MEMORANDUM

RE: Mount Felix proposed residential development preliminary staff comments
2000 Level Road
Havre de Grace, Maryland 21078

Please find the Department of Planning review and comments below for the Conceptual Site Plan, Landscape and Lighting Plan submitted on January 22nd for the informal conceptual site plan review and comment with the Planning Commission on February 15th, 2024.

Site Plan, Landscape and Lighting Plan Review – Mt. Felix

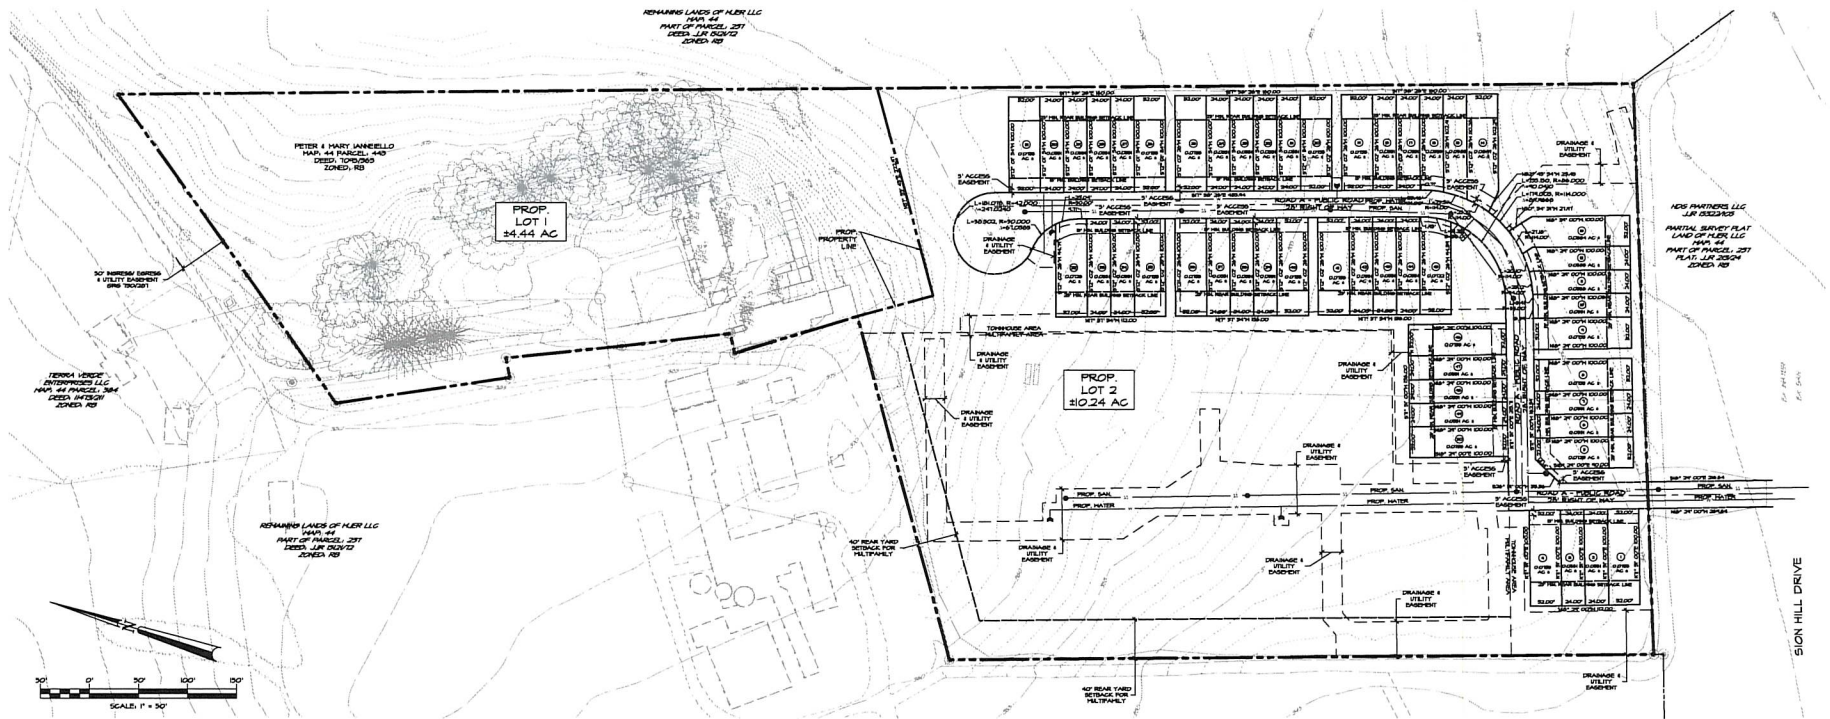
- **Suggest:** the areas devoted to stormwater management facilities shall be vegetatively buffered as appropriate if they are not suitable for active or passive recreation and/or forest conservation easements while still maintaining the SWM design intent and minimum safety standards as applicable.
- **Suggest** moving the proposed parking lot entrance between Building 1 & 2 to line up with the proposed throughway access to the north side of Building 3 (in line with the utility easement) and

relocate dumpster accordingly per 15(C)(2). This will also improve 102-9 parking lot conditions in terms of glare, connectivity and design.

PRELIMINARY SUBDIVISION PLAN
MOUNT FELIX
SUBDIVISION

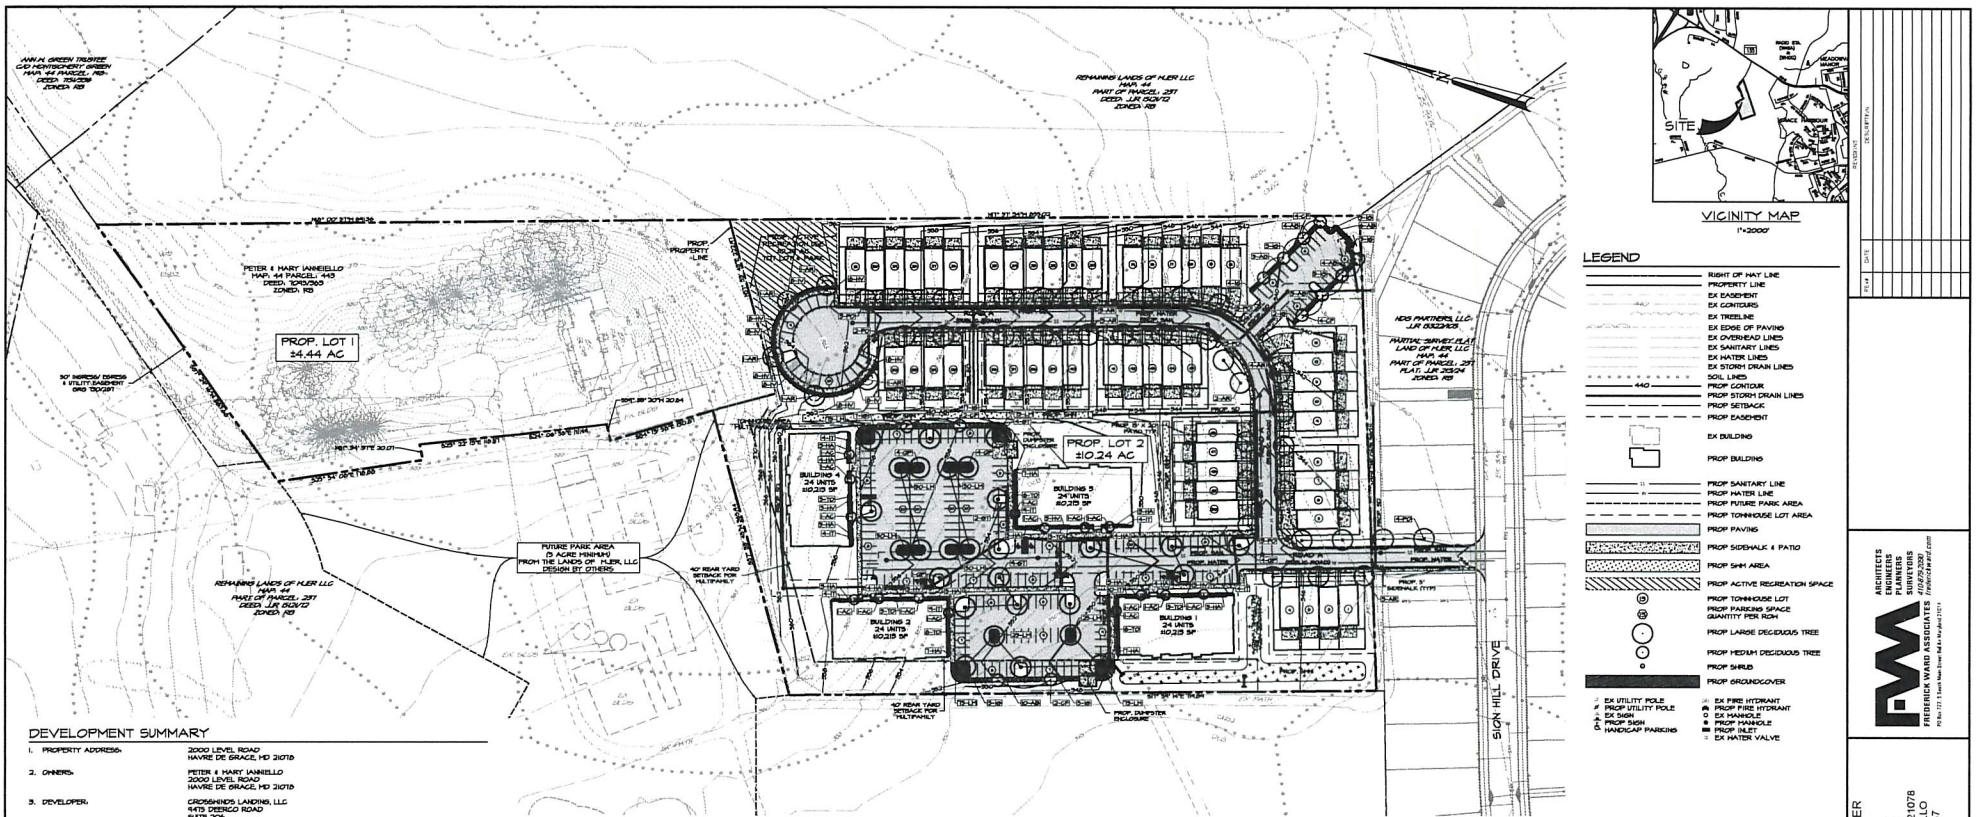
- **§155-12(A):** Please screen proposed dumpster enclosure with evergreens.
- **§155-15(B)(1):** Private entrances/exits must be located at least 50 feet from the closest unsignalized intersection.

- Lot #5 and Lot #50 seem to be affected by this Code section and the driveways will need to be realigned.
- **15(C)(2) & (C)(4):** Please provide a plan to the City indicating large trucks and emergency vehicles can circulate throughout the site safely and efficiently.

- **15(C)(3):** Are there any marked delivery spaces for the condos?
- **15(C)(5):** Since the site has more than 25 parking spaces, internal pedestrian pathways must be provided throughout the site.

- **15(D)(5):** Please design the five-foot (5’) proposed sidewalk to be in addition to, not included in, the twenty-two-foot (22’) length of townhome driveways--for a minimum of twenty-seven feet (27’) all the proposed townhomes. This same logic will apply to the multifamily sidewalks near parking lots.

LANDSCAPE NOTES & DETAILS
MOUNT FELIX
SUBDIVISION

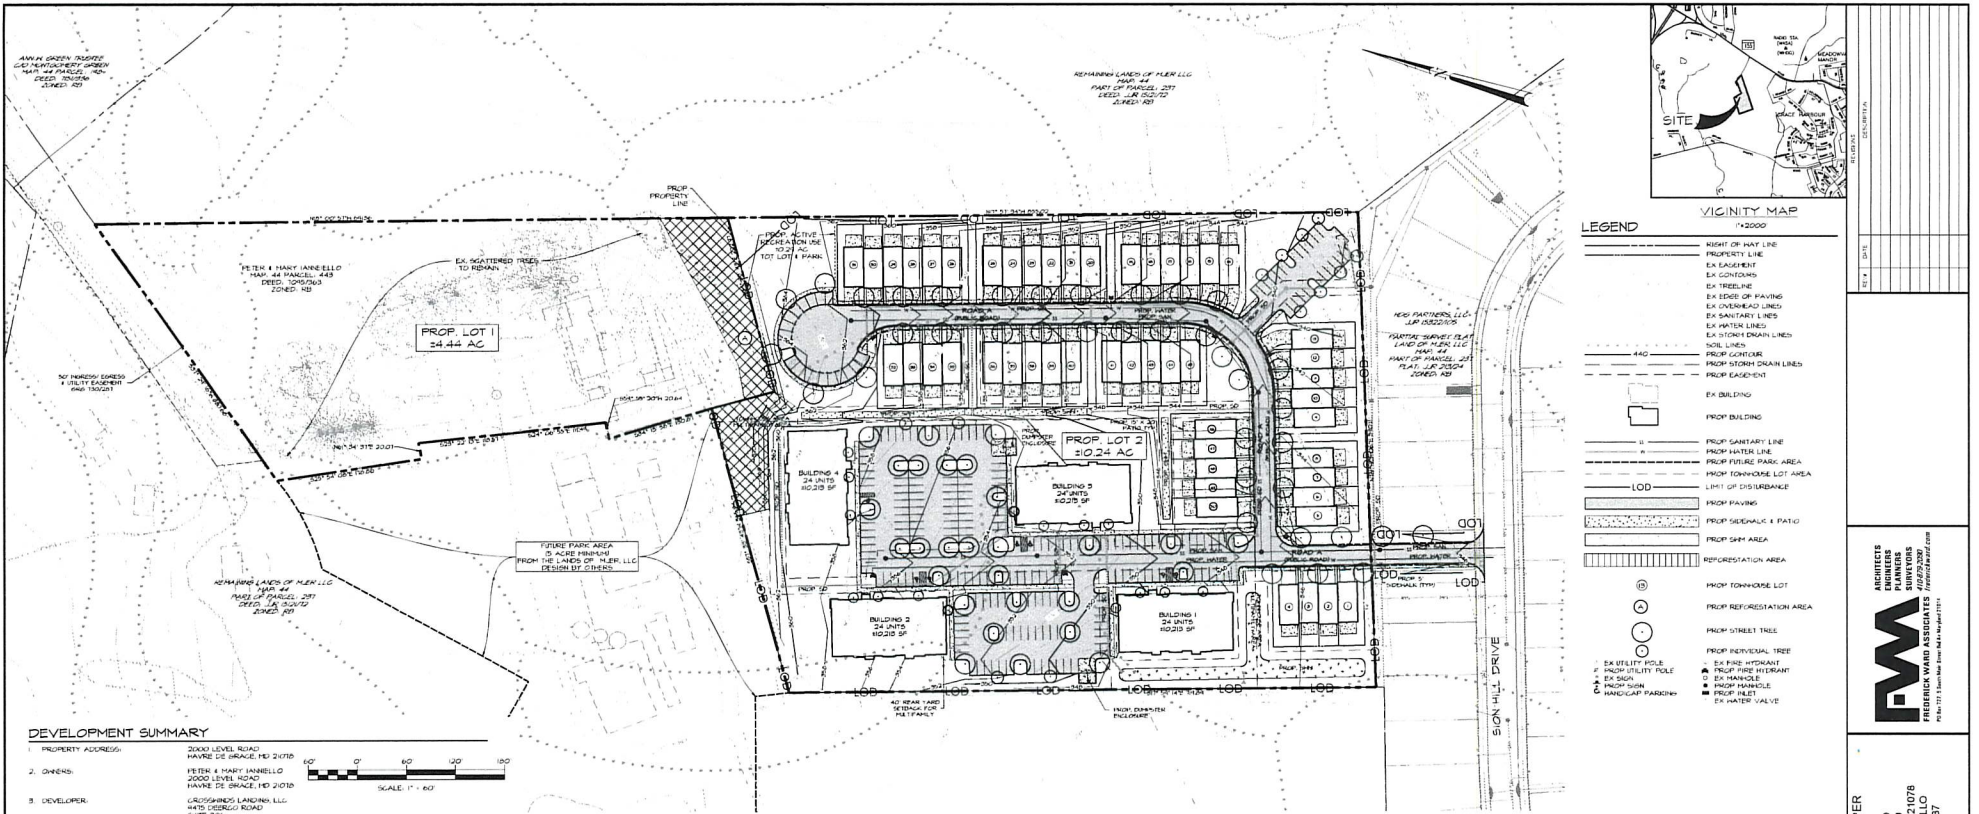
- **§186-11**: Distance from street corners / intersections. “No street tree shall be planted closer than thirty-five (35’) to any street corner measured from point of nearest intersecting curb lines. Please relocate trees at ‘Road A’ intersection to meet minimum standards in §102-7(D), 7(E) and §102-8(5). We recommend relocating street trees near Lot #5, Lot#14/Lot #15 and Lot#50 to meet the thirty-five feet (35’) standard. We are open to alternative suggestions to meet compliance for internal vehicular circulation safety and standards

- **§186-11 & 102-8(B)(8)**: Also, no street tree shall be planted closer than twenty (20’) to any fire hydrant. Please relocate FH/Street Tree near Lot#5 and Lot#45.

- **§186-12 & 102-8(B)(8)**: **Utilities**: No street tree shall be planted under or within 10 linear feet of any overhead utility wire, or over or within five linear feet of any underground water line, sewer line, transmission line or other utility. Recommend modifying parking lot in SE corner between Lot #13 and Lot #14 to satisfy these requirements. Specifically, light pole in SW parking lot near building 1 and street light pole near the street tree near Lot #8.

- **Please clarify** planting symbol ‘AB’ which is not listed on plan. Perhaps this is meant to be ‘AG’.
- **Please include §102-5** Topsoil section A through C on the ‘Landscape Notes’ section of the landscape plan.
- **7(M)**: A variety of plant species are encouraged to avoid monocultures, to encourage long-lived species and to promote wildlife habitat. Of the required tree plantings and of the shrub plantings, no more than 33% may be of one species. See below:
- **7(I) Small Street Trees**: 55% singular species. Please add additional small street trees to meet the 33% species diversity requirements. We suggest you provide at least one additional species of

- **9(E)(1):** Plant a buffer along the SW parking (adjacent to Lot no. 50) to prevent street light and headlight glare from vehicle ingress/egress of parking lot along dwelling.

- **§102-9(E): Recommend** planting evergreen shrubs along all building facade to meet 60% evergreen requirements. *Itea Virginica* is not an acceptable evergreen as it is deciduous. Please provide an alternative coniferous or deciduous evergreen such as a juniper, holly or such to satisfy requirements.

- **Recommend** parking lot perimeter landscaping for parking lot between building 1 & 2 to meet **9(D)**. Also, recommend connecting the parking lots via sidewalk for seamless pedestrian access.

FOREST CONSERVATION PLAN
MOUNT FELIX
SUBDIVISION

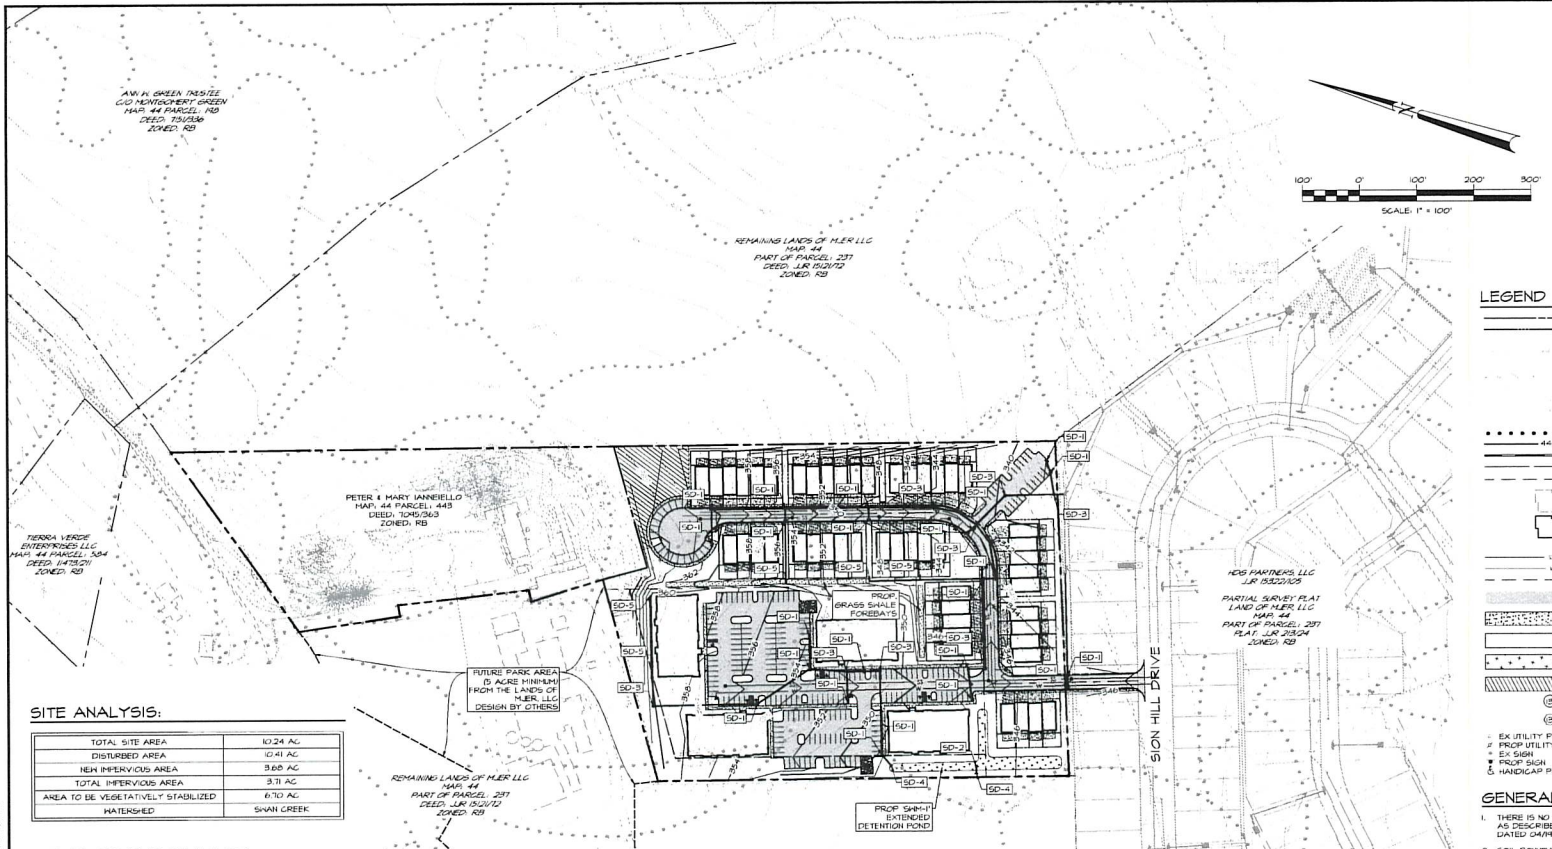
- **81-5** A Forest Stand Delineation (FSD) will be required. A Forest Conservation Plan (FCP) has been submitted in conjunction with the concept plan for review and approval but no FSD has been completed.
- **81-9(A)(2)** Street Trees do not count towards the FCP because the City does not have a “Tree Management Plan”. Please revise the FSD & FCP accordingly to meet the FCP requirements.

**CONCEPT STORMWATER
MANAGEMENT PLAN**

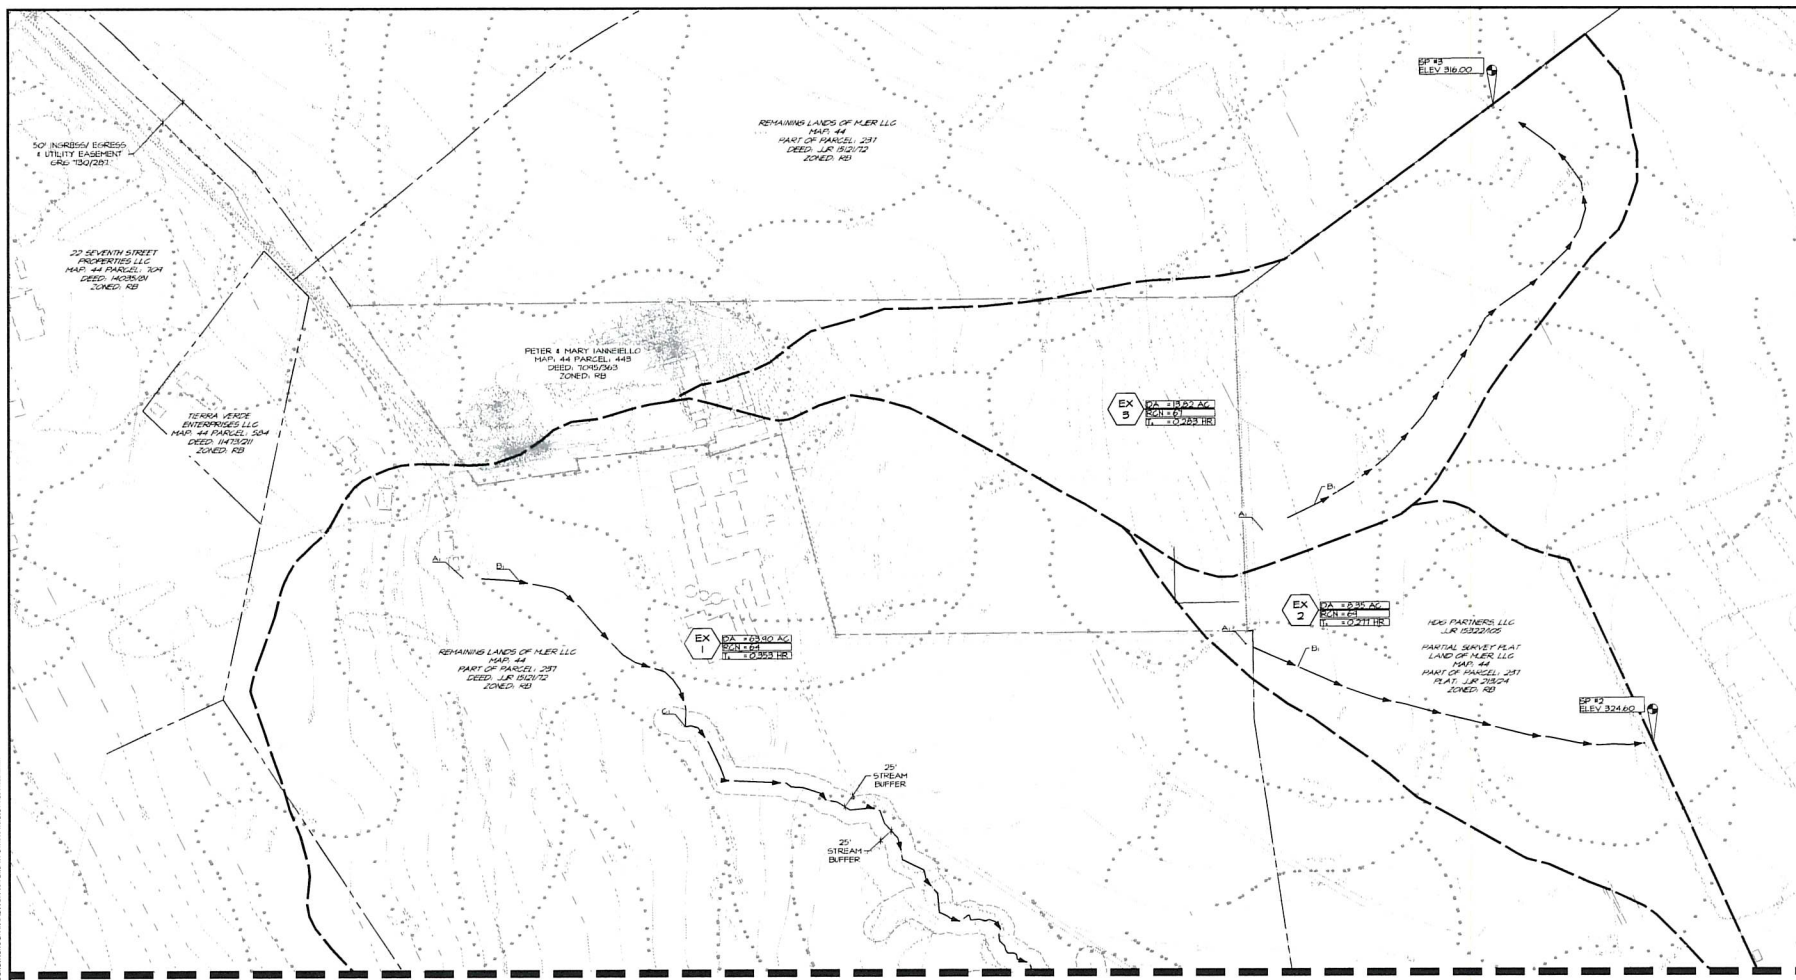
- **155-18(E)**: Below are comments from the in-house review of the concept stormwater management plan. Future submittals will need to be reviewed and approved by the City’s consulting engineer.
 - Owner signature is required;
 - Plans must be signed and sealed by a licensed engineer;
 - A plan needs to be provided that allows for discharge from Mount Felix to Sion Hill. Per the City Code, all stormwater must be contained on the subject property;
 - Computations need to be verified:
 - Need to resize pipe to Sion Hill;
 - Is SDWG #3 able to handle additional run off?
 - Can proposed SWM #1 handle all of the run off?
